**NAVAL AIR STATION ALAMEDA, CALIFORNIA  
HYDROGEOLOGY AND PROPOSED CHANGES FOR  
PHASE 5 OF THE RI/FS**

**April 10, 1991**

### NAVY RESPONSE TO DHS COMMENTS DRAFT HYDROLOGY AND PROPOSED CHANGES FOR PHASE 5 OF THE RI/FS - NAS ALAMEDA

**FIGURE 1**  
**PROPOSED MONITORING WELL LOCATIONS**  
**FOR SWAT**  
**(PHASES 5 & 6 OF RI/FS)**

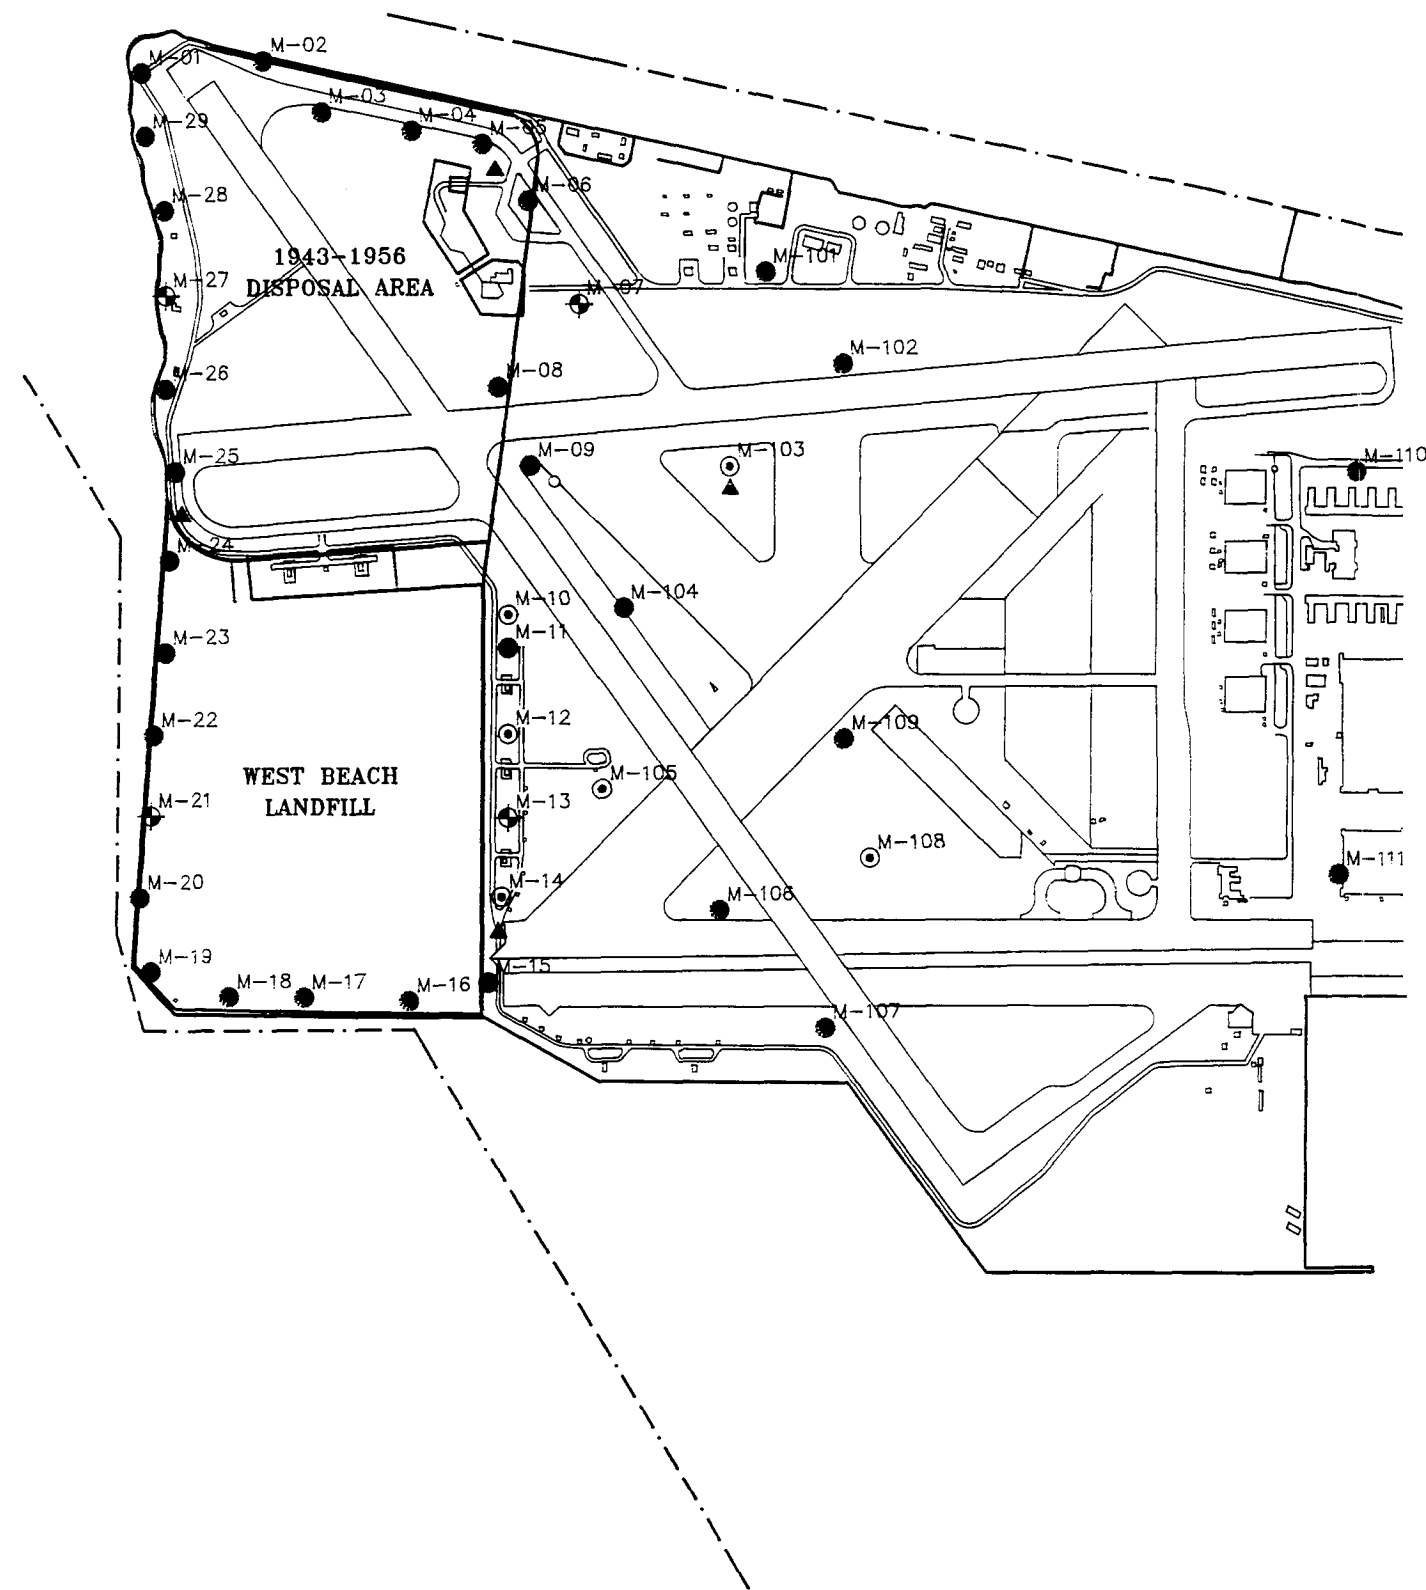
*Comment No. 2. Section 5.1, Page 18 - The Department concurs with the technical justification for not placing intermediate wells in the east, south or north areas of the landfills. It would appear that the Bay Mud Aquitard does extend from approximately the middle of the landfills westward. However, the western portion of the Bay Mud Aquitard would hinder the downward migration of the "sinkers" from the western portion of the landfills. The Department recommends that monitor wells be installed along the western side (Figure 1 locations; M-01, M-02, M-18 through M-29) of the landfills to monitor for contaminants at the Bay Mud Sand/Bay Mud Aquitard interface.*

*Line 9. Reference Figure 1.*

Response: The recommendation to install 14 additional ground-water monitoring wells, screened 10 feet above the Bay Mud Aquitard, has been incorporated into this report. See Section 4.2, page 17, paragraph 2 and Section 5.1, page 18, last paragraph (continues to page 19).

**FIGURE 5**  
**CROSS SECTION B - B'**  
**WITH WELL CONSTRUCTION DETAILS**  
**FOR M103A, B**

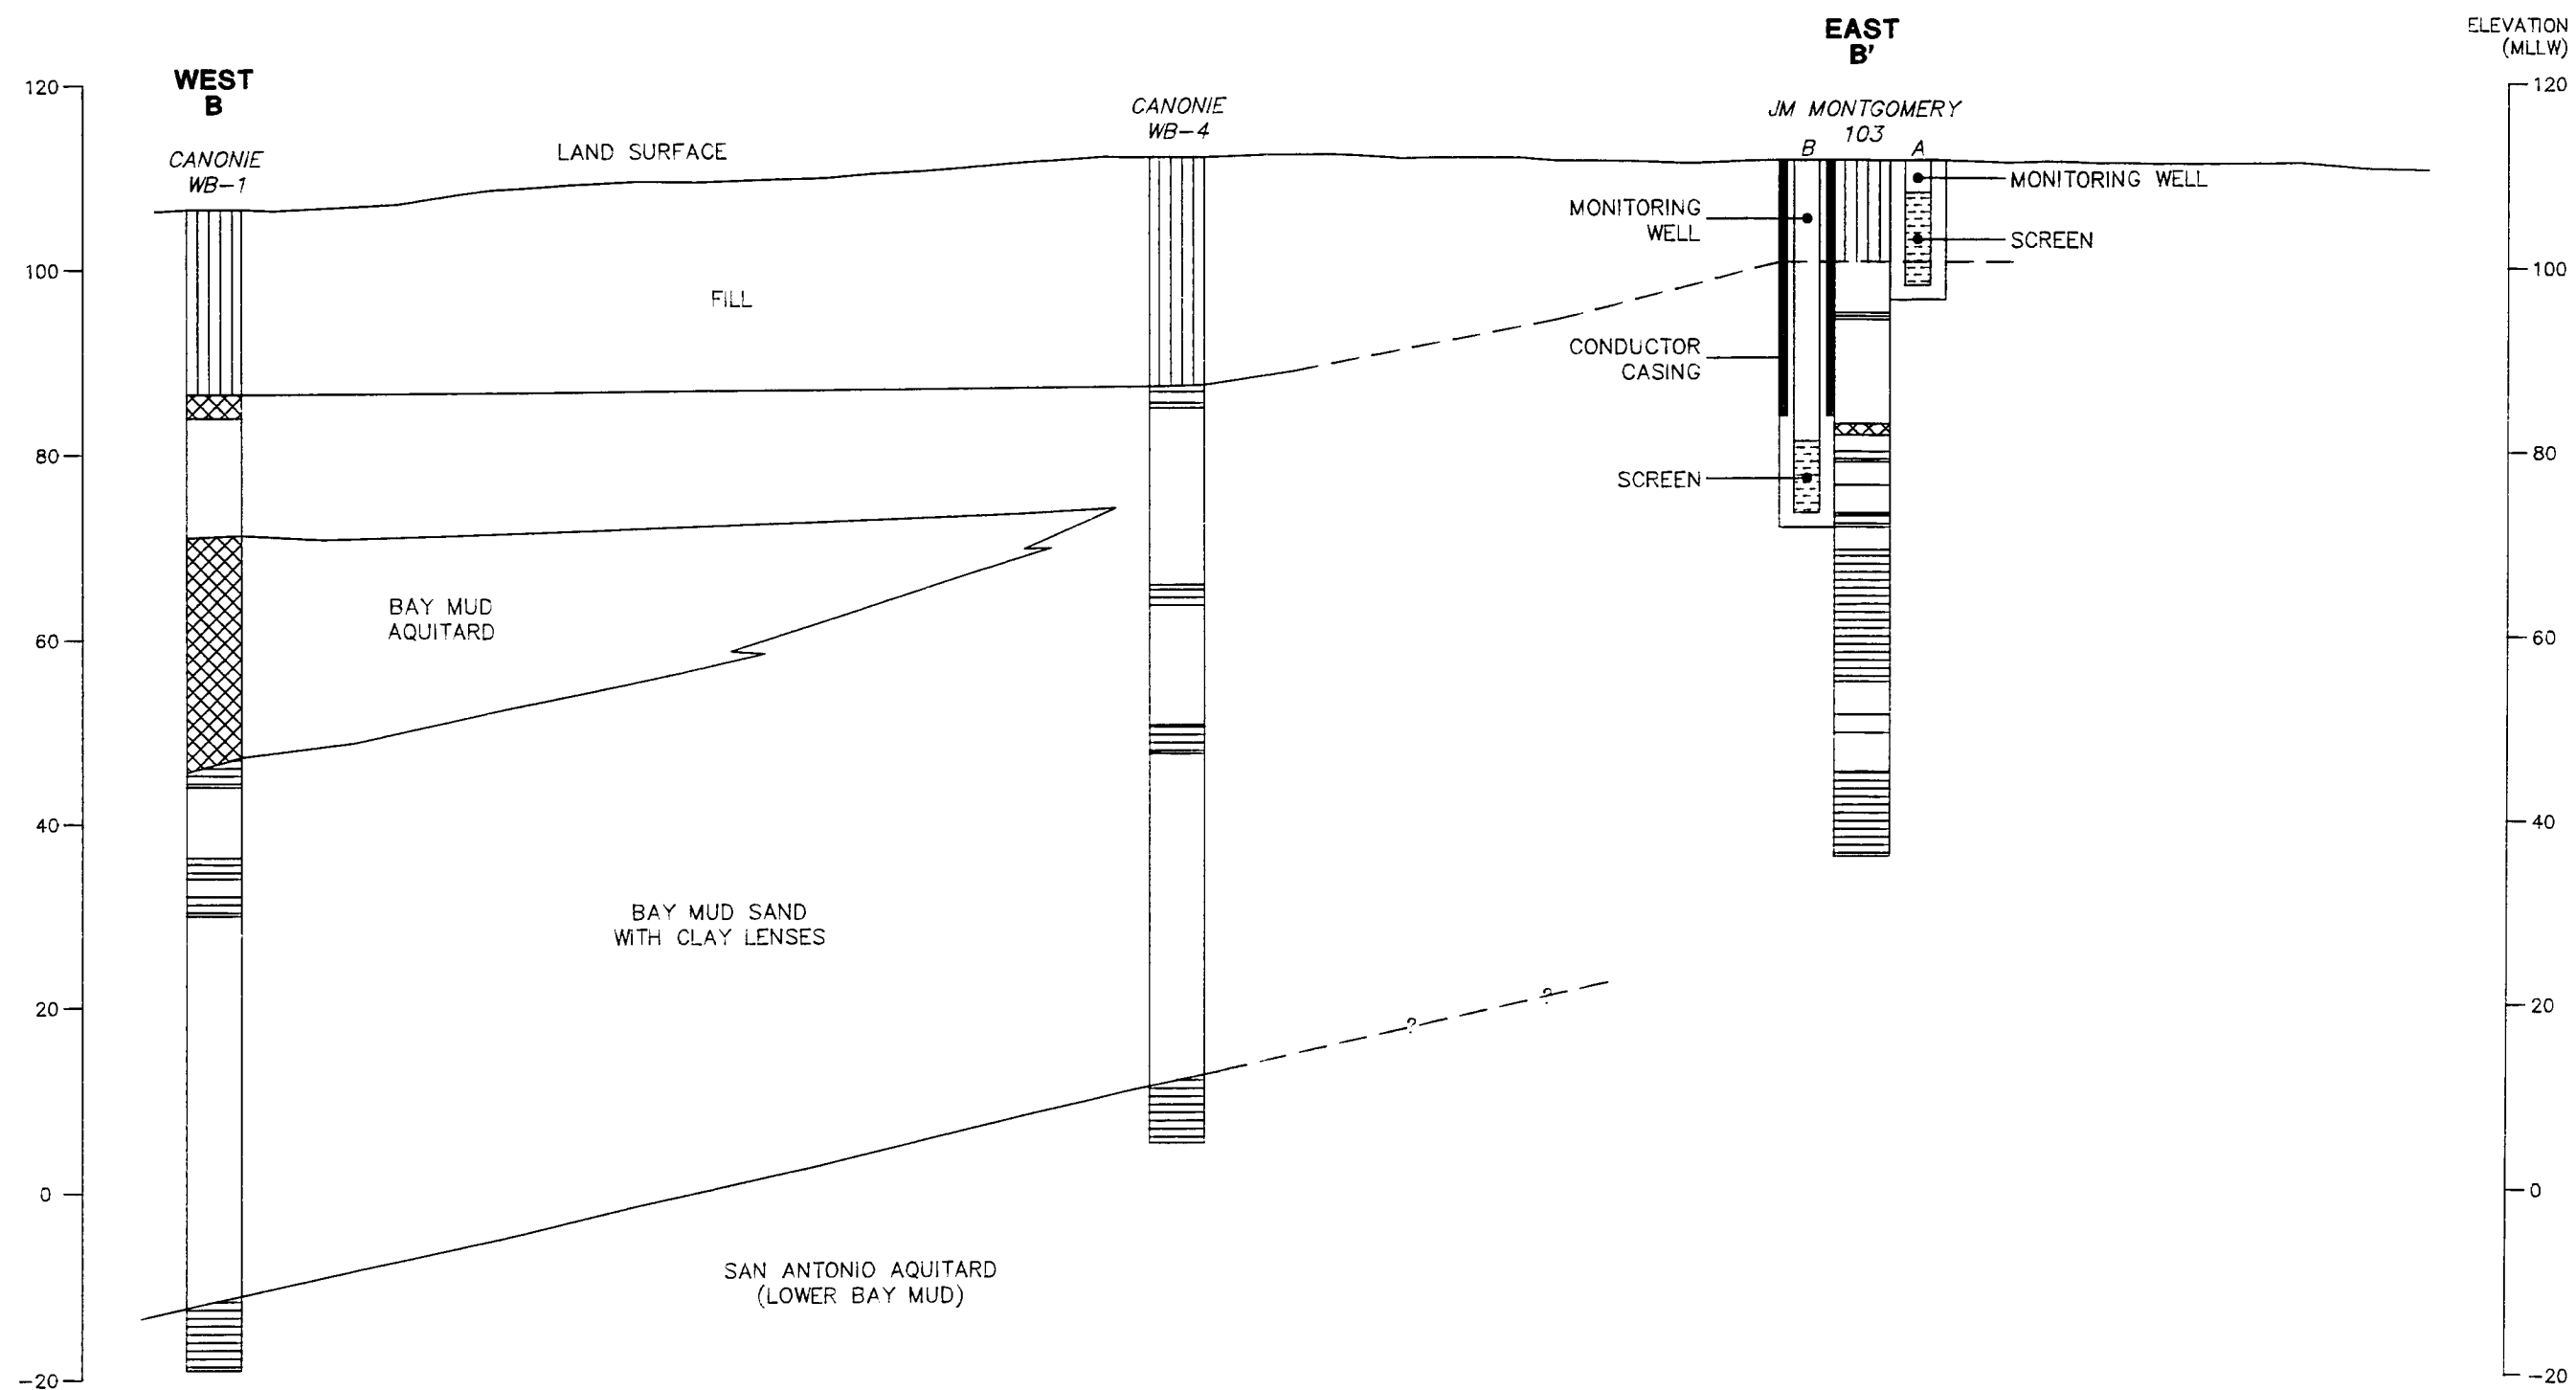
*Figure 5. The "Fill" line between borings WB-1 and WB-4 needs to be corrected to be above the soft clay in WB-1.*

Response: Corrections have been made.

**FIGURE 7**  
**CROSS SECTION D - D'**

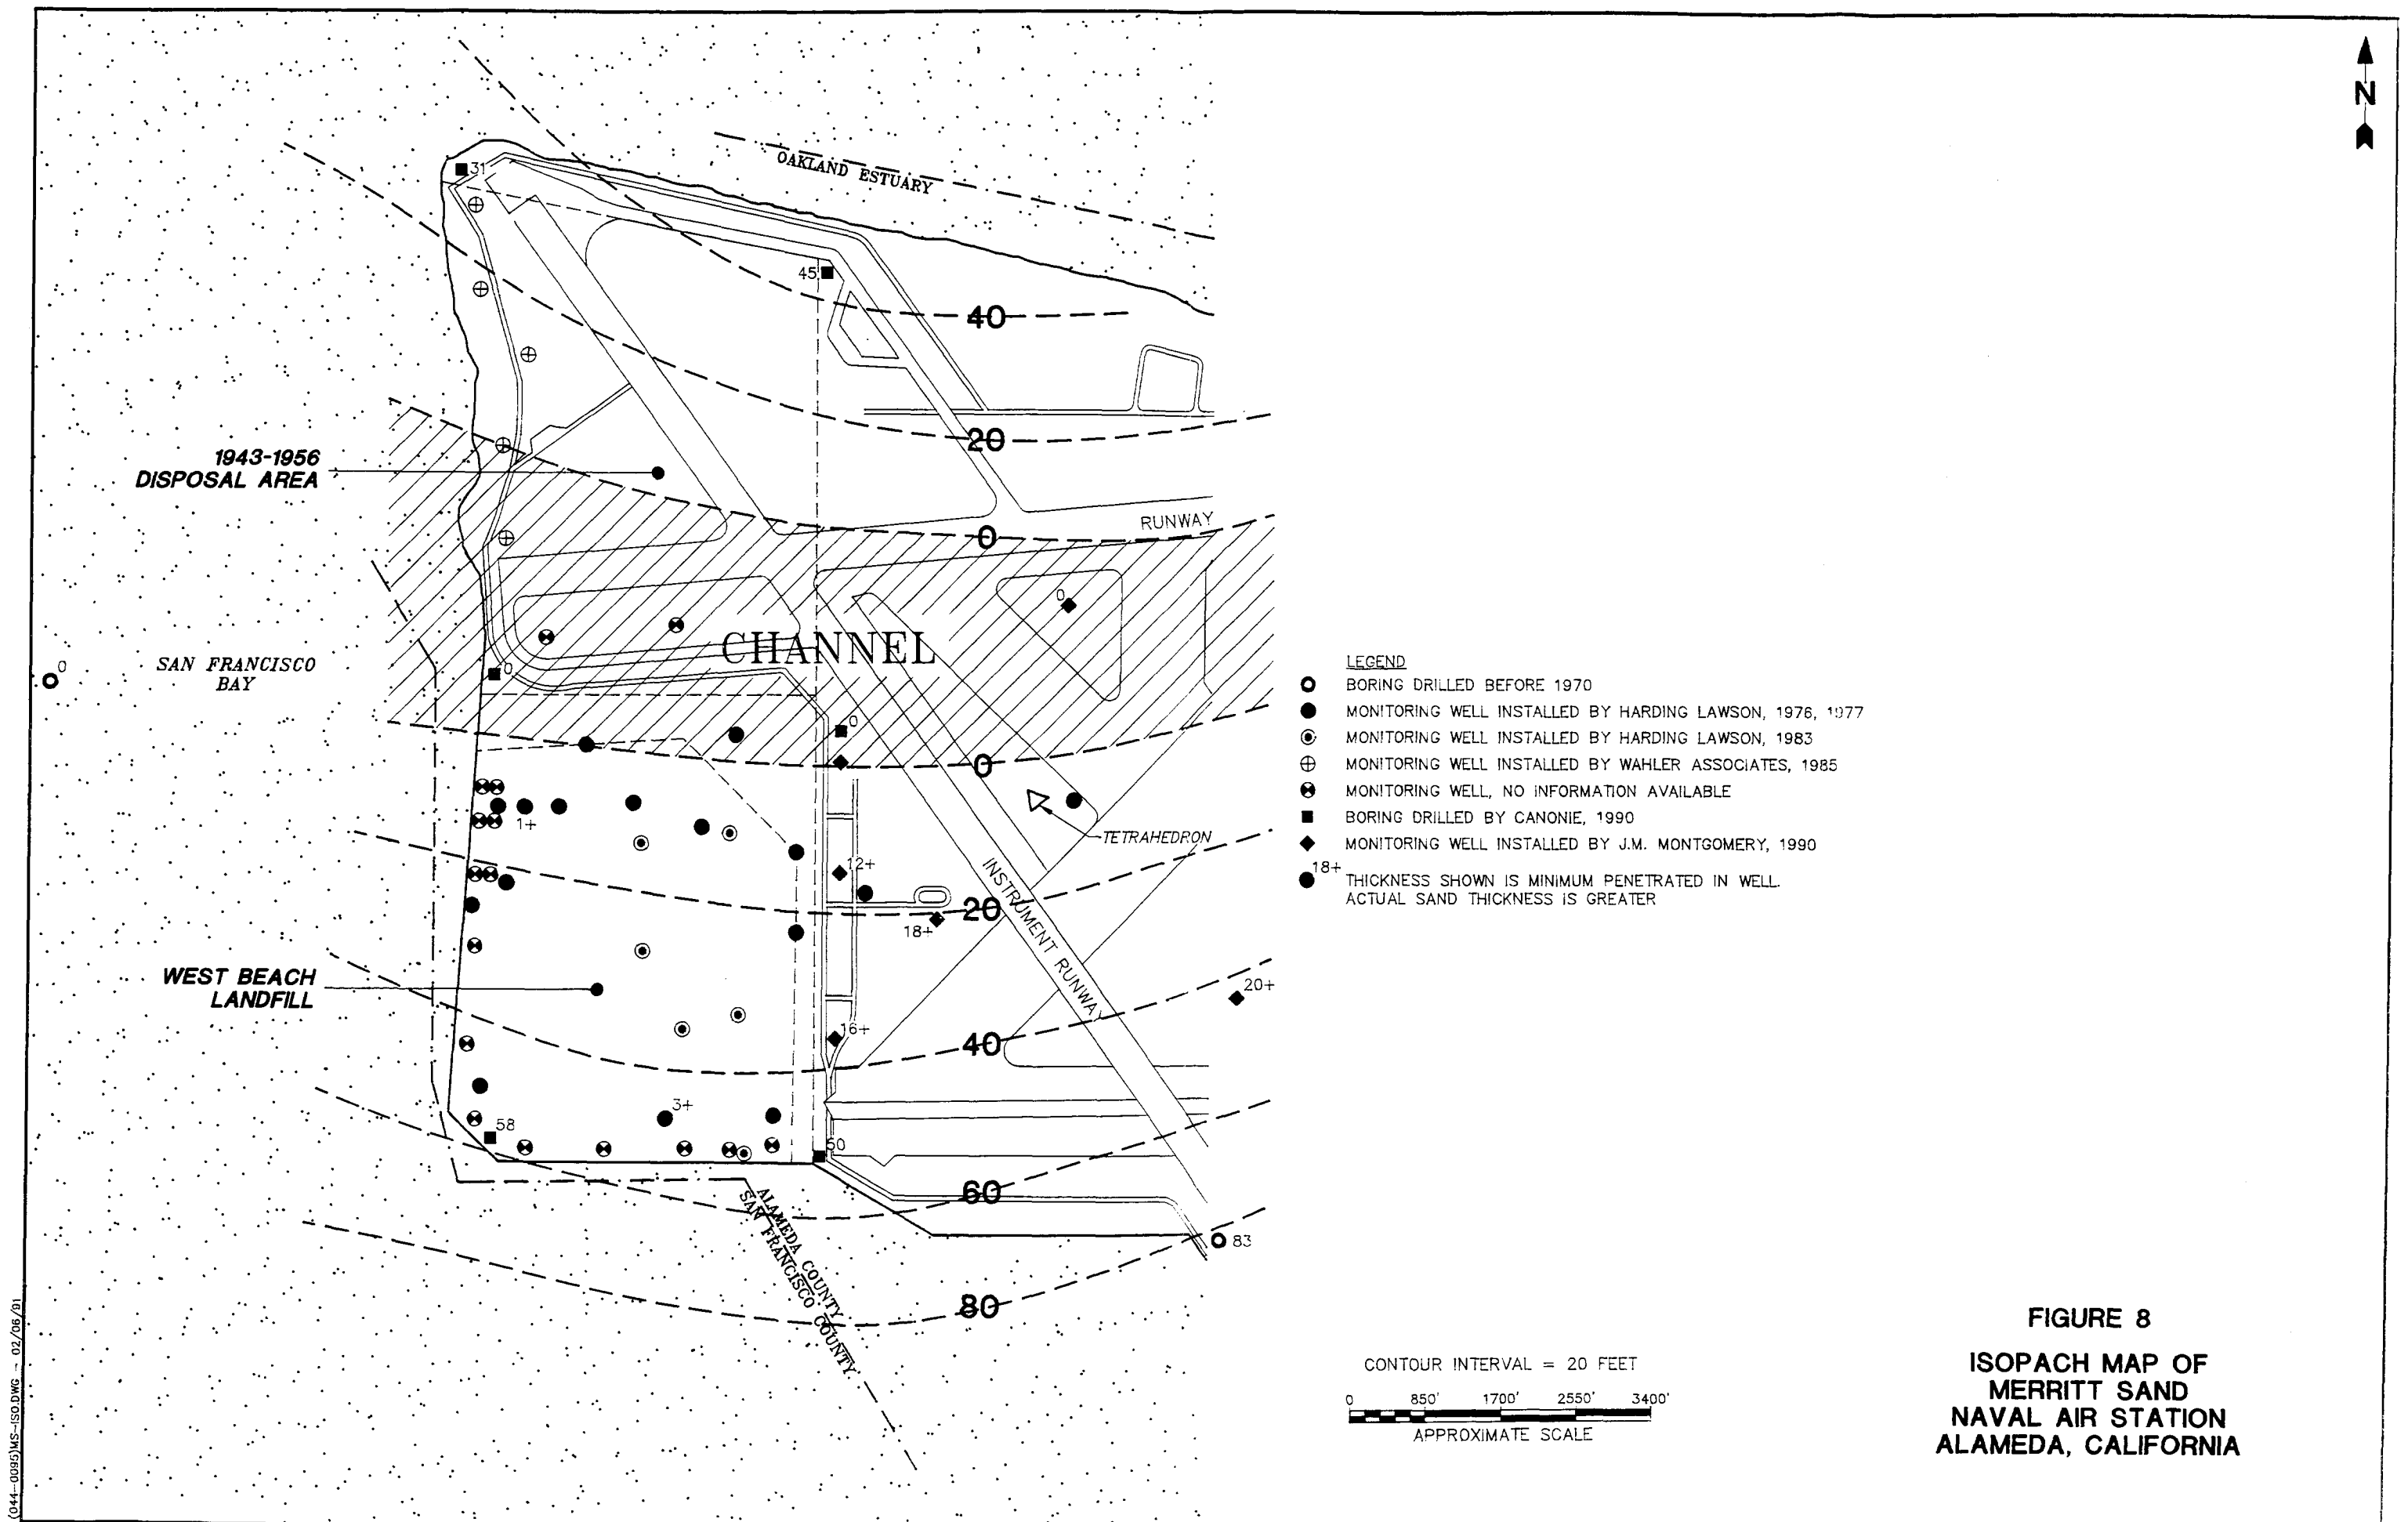
*Figure 7. Legend - Box needs symbol added to represent the Yellow-Brown sand.*

Response: Corrections have been made.
